Architectural Review Board Staff Report

Project Type: Site Development Section Plan

Meeting Date: October 23, 2014

Description: **St. Luke's Hospital Northwest Campus 5th ASDSP**: An Amended Site Development Section Plan, Amended Landscape Plan, Lighting Plan, Architectural Elevations and Architect's Statement of Design for a 38.28 acre tract of land zoned "MU" Medical Use District located northwest of the intersection of South Woods Mill Road and Brookings Park Drive.

Figure 2: Sight-Line Study

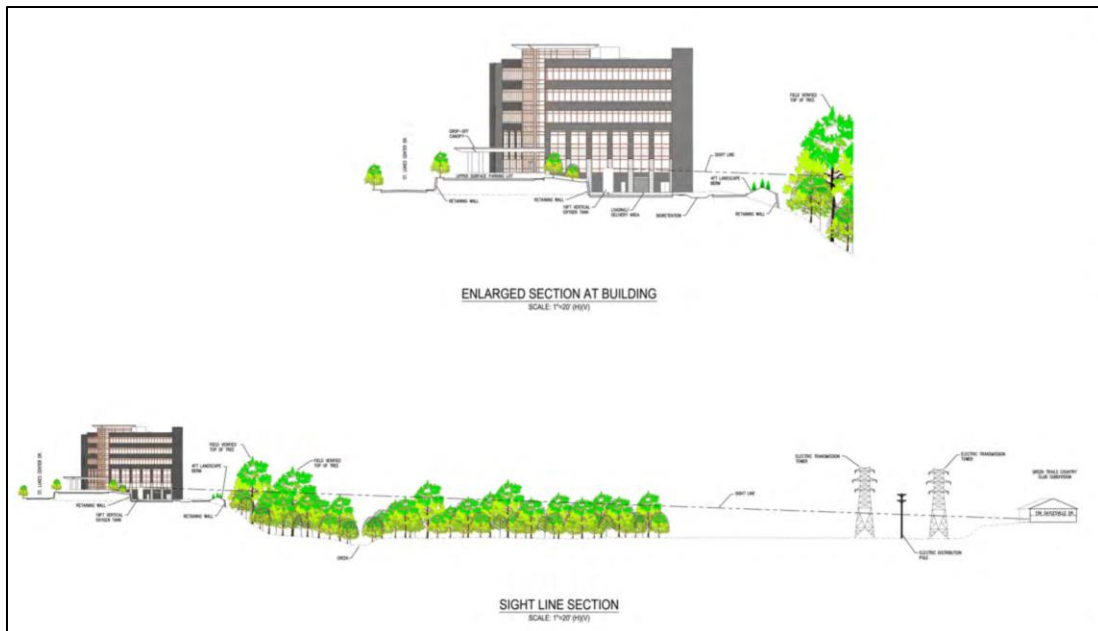
site loses elevation as you move east and north. The proposed building addition is 86 feet in height above adjacent average grade and similar in height to the existing structure on site. A site visit to the western residential properties revealed that the existing medical building is not visible through the thick vegetation. While the existing structure cannot be seen currently, after trees have lost leaves, it may be possible to see these structures. Staff is continuing to evaluate the proposal versus surrounding topography.

Screening is provided for the trash container, Oxygen tank and Chillers. These structures will be placed on the north elevation and be screened from view by the building to the south, a retaining wall to the east and the landscape berm to the west. The sight-line study documents screening for these structures. While no screening is planned from the north, this area is below adjacent grade and will be additionally screened from view with future building additions to the north. No public visibility of this area is available, which is the intent of the City requirements. Additional mechanical equipment will be roof mounted and screened per the UDC using a metal screen wall.
